# HISTORIC AND DESIGN REVIEW COMMISSION

**HDRC CASE NO:** 2024-124  
**ADDRESS:** 434 ADAMS ST  
**LEGAL DESCRIPTION:** NCB 2879 BLK 4 LOT 18 S 15 FT OF 16  
**ZONING:** RM-4, H, HL  
**CITY COUNCIL DIST.:** 1  
**DISTRICT:** King William Historic District  
**APPLICANT:** Jake Dady /DADY JACOB MATTHEW  
**OWNER:** Jake Dady /DADY JACOB MATTHEW  
**TYPE OF WORK:** New construction of a two-story accessory structure  
**APPLICATION RECEIVED:** May 31, 2023  
**60-DAY REVIEW:** July 30, 2023  
**CASE MANAGER:** Jessica Anderson

The applicant requests a Certificate of Appropriateness for approval to construct a two-story accessory structure.

## PLOT PLAN

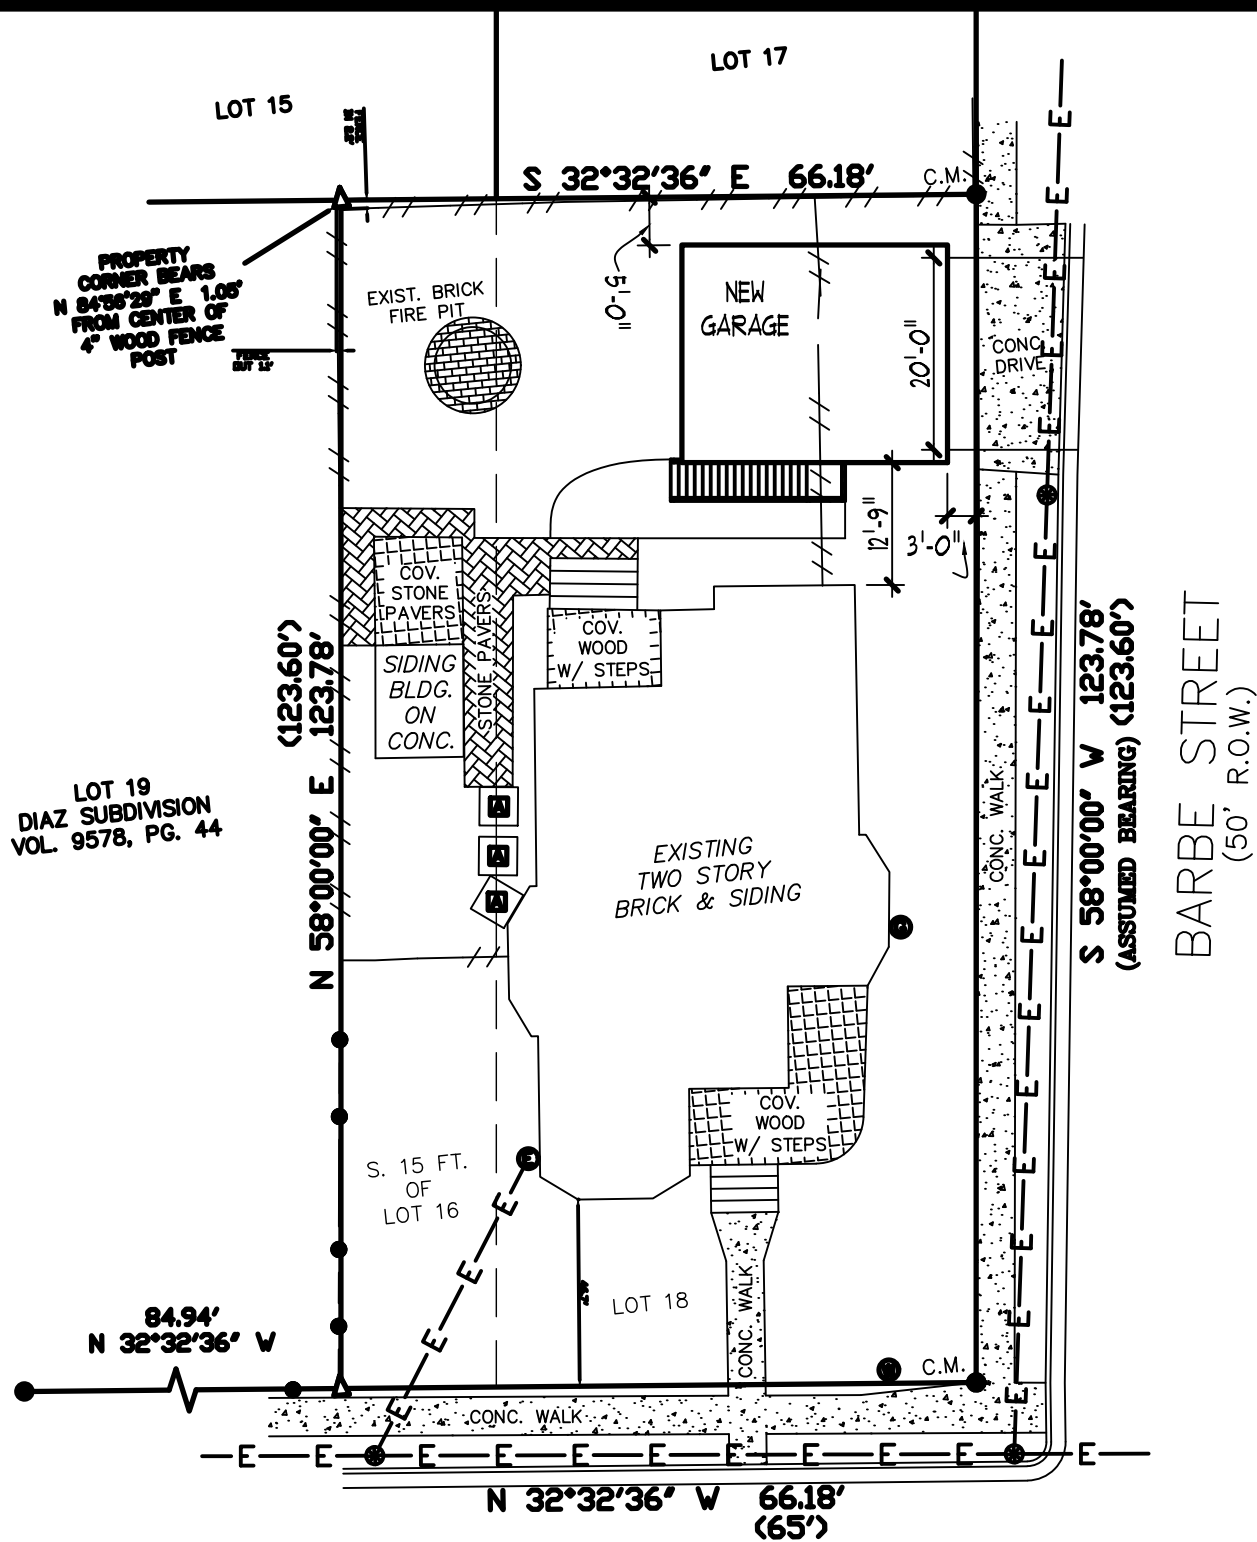
- d. **ORIENTATION & SETBACKS:** The applicant has proposed both an orientation and setback for the new accessory structure that are consistent with the Guidelines for New Construction 5.B and consistent with a variance issued by the Board of Adjustment allowing a 15' variance from the minimum 20' garage setback requirement to allow a garage to be 5' from the side property line.

- i. That the applicant proposes a garage door that is wood or wood-look, as noted in finding e.
- ii. That the applicant proposes exterior doors that are fully wood and relate in design to the period of construction of the primary structure, namely a Folk Victorian style, as noted in finding f.
- iii. That the applicant proposes a window product that conforms to standard specifications for windows in new construction, namely a high-quality wood or aluminum-clad wood window product with true muntins, as noted in finding g.
- iv. That the exterior staircase and railing be constructed of wood rather than metal, as noted in finding h.
